NOTICE OF A TYPE II DECISION ON A PROPOSAL IN YOUR NEIGHBORHOOD

CASE FILE NUMBER: LU 14-222880 DZ

Site Address: 4134 N VANCOUVER AVE

Case Type: **DZ** (Design Review)

SKIDMORE BUILDING - NORTH ELEVATION
ELEVATION KEYNOTES
1. UNLESS OTHERWISE NOTED, ALL DIMENSIONS ARE IN FEET AND INCHES.
2. DIMENSIONS SHOWN ARE TO FACE UNLESS NOTED OTHERWISE.

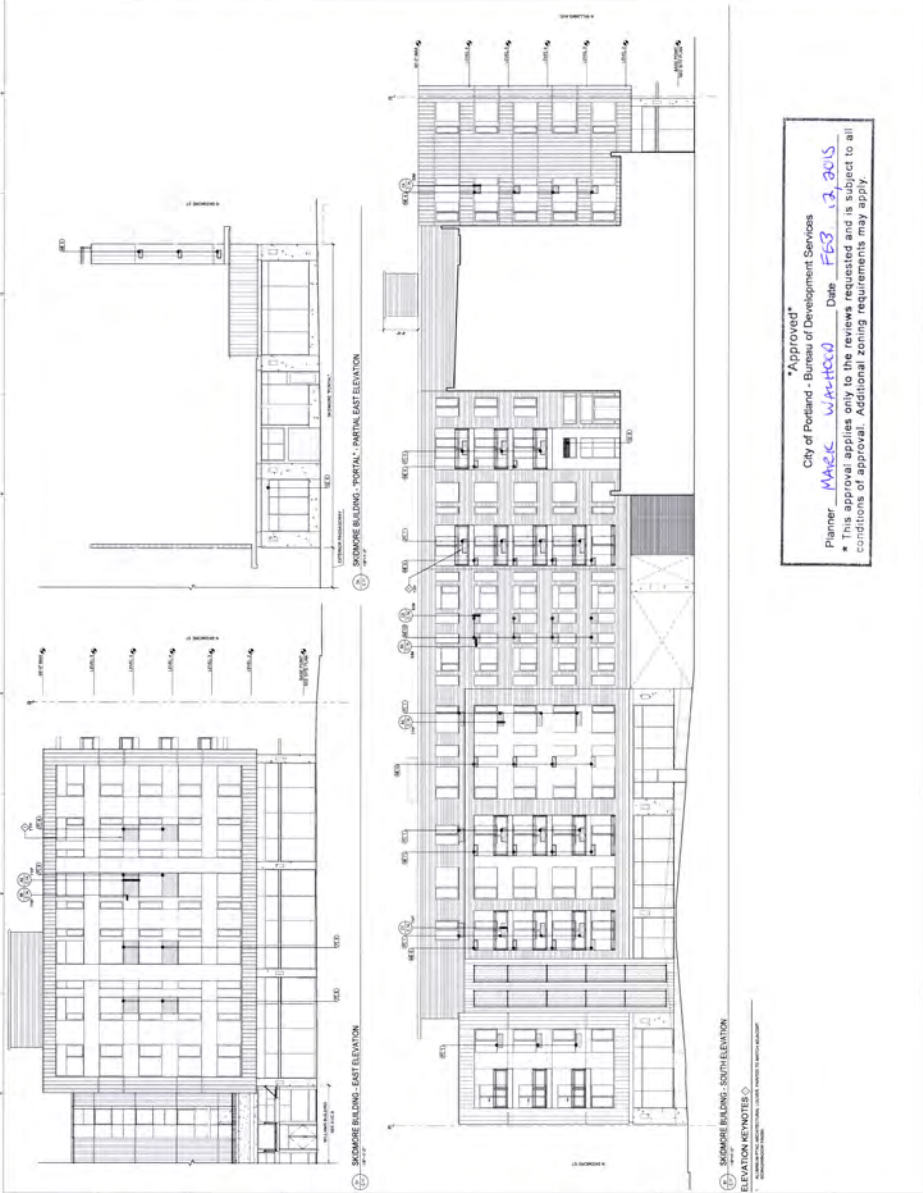
Findings for E1: The alterations at ground level are limited to modest changes necessary to accommodate an existing telecommunications hub facility on the site along the N. Skidmore frontage. As originally proposed, two rectangular landscaped beds would be provided in an area that was previously shown as an extension of the adjacent sidewalk. The change back to sidewalk paving maintains the generously-proportioned sidewalk corridor in an uninterrupted, continuous pedestrian sequence along the Skidmore frontage. The utility boxes are relatively modest in scale, and not out of character with other electrical and signal boxes found in sidewalk zones. The modest alcove created within the building along Skidmore does not have significant impacts on the pedestrian environment, as clear glazing is maintained facing the street. There are no changes with regards to the pedestrian environment and interactions with the vehicle areas on the site as previously configured.

Findings for D8: The proposal includes a significant number (243) of new louvers on the exterior, although this is for the entire project which includes three distinct 'buildings' over a basement parking level. The proposed louvers

are applied in a manner consistent with the approach made with the original louvers, except individual panels are typically larger. When not contained within balconies which help to obscure their visibility, the louvers are generally applied in vertical alignment with fixed window openings directly above, to integrate with existing lines on the building. Several of the smaller previously-approved louvers on the top floors of the Skidmore and Williams Buildings were moved to the roof, to create a cleaner and distinct pattern on the top floor. In several locations on the Skidmore Building the applicant has integrated the louvers into the window systems, to avoid penetrating the metal siding as much as possible.

- C. All exterior louvers on the building, except those contained behind a railing within a patio or balcony wall, shall be installed with outermost louver screens flush with the adjacent material. All exterior louvers on the building, including those within patios or balconies, shall be painted to match the adjacent material.

16 VANCOUVER BUILDING - WEST ELEVATION

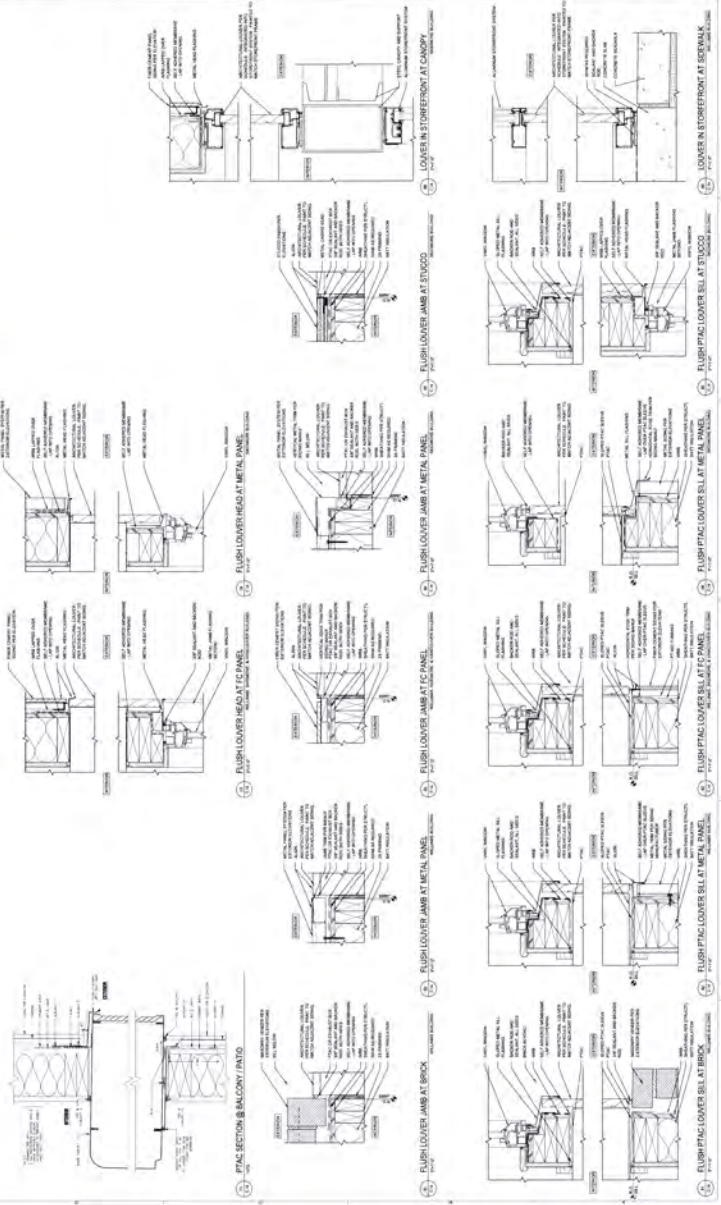
On the townhomes, the louvers are also arranged in vertical alignment with and below fixed windows directly above. On the primary west elevation only one row of louvers are visible, as the top floor units are hidden behind terrace walls. The louvers on the townhomes also avoid the street-facing Meranti wood elements, which are key to the successful design of this building.

EXISTING ABOVE GRADE UTILITY ELEMENTS

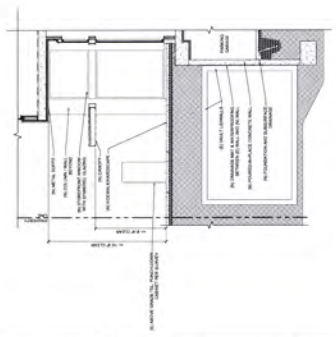
Staff originally requested that the visible telecommunication equipment (punchdown cabinet and vault access hatch) be provided with an artistic paint treatment to make them a feature or novelty on their own in the sidewalk corridor. Because the equipment is owned by Century Link and not under the control of the applicant, and because the equipment is already in place legally, it is impractical to require this artistic painting treatment. However, the applicant has indicated a willingness to paint the equipment, if Century Link agrees in the future. To memorialize this intention, and clarify that this may happen later without future design review, an optional condition of approval will clarify that these pieces could be painted by an artist without triggering another design review. *Therefore, this guideline is met.*

- B. The applicant is encouraged to work with Century Link to provide an artistic paint treatment to the two above-grade elements of the telecommunications hub along the N. Skidmore Street frontage. Any future paint treatment of the punchdown cabinet and vault access hatch at this site is allowed without Design Review.
